30 October 2018

RE: Vickery Coal Mine, Vickery Extension Project Environmental Impact Statement

Figure 1 Boggabri's town bore

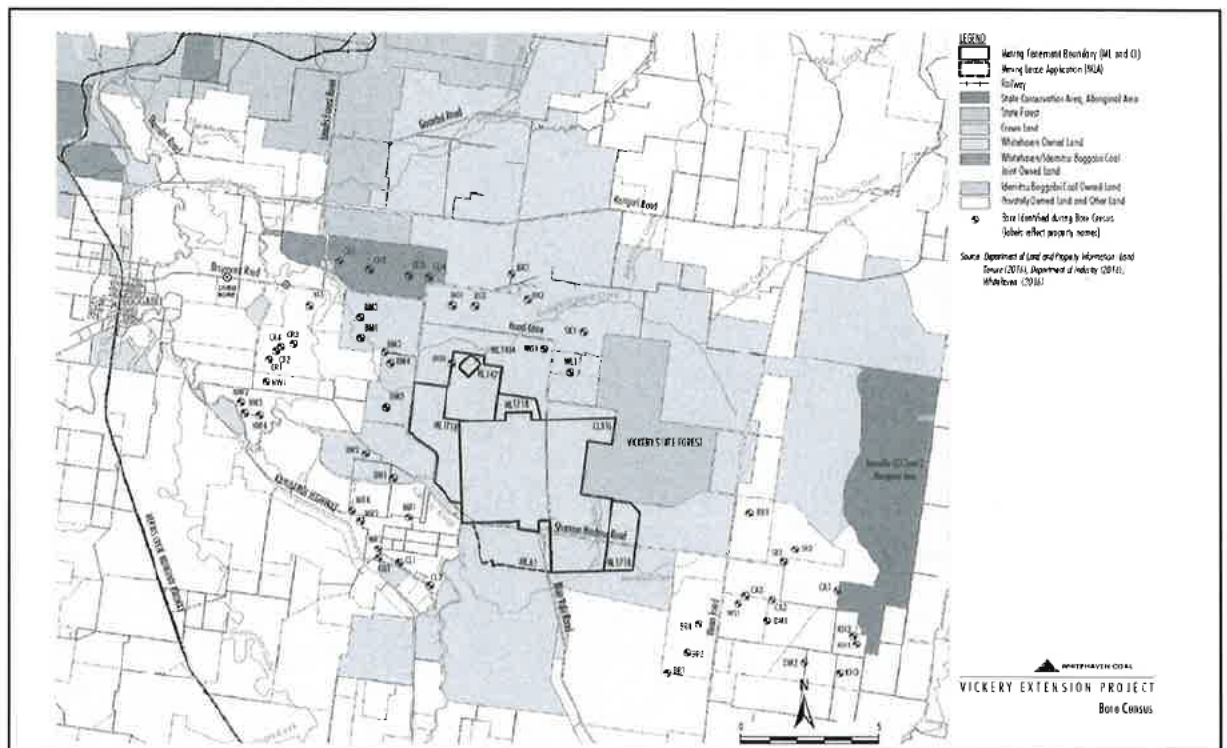
The overall water balance of a mine site is an important consideration when assessing surface water risks. Variability in local hydrology may result in a shift between a mine being water positive or negative (Northey et al., 2016). According to the EIS (Appendix B):

Periodic review and revision of the site water balance will be undertaken over the life of the Project to record and document the status of inflows (water capture), storage and consumption (e.g. dust suppression and Project CHPP water supply) and to optimise water management performance. Monitoring will be undertaken over the life of the Project to provide data for refinement of the site water balance (Section 7.3.2). (p. 7-2)

15. That DPE satisfy itself that the site water balance is adequate to meet with operational requirements of the Project including any additional environmental management and rehabilitation requirements.
16. That DPE require as a condition of consent that:
 - a) *The proponent shall implement a water management plan, which as a minimum includes the annual review of the site water balance over the life of the Project.*
 - b) *Results of the annual review of the site water balance are published in a publically accessible and transparent way.*
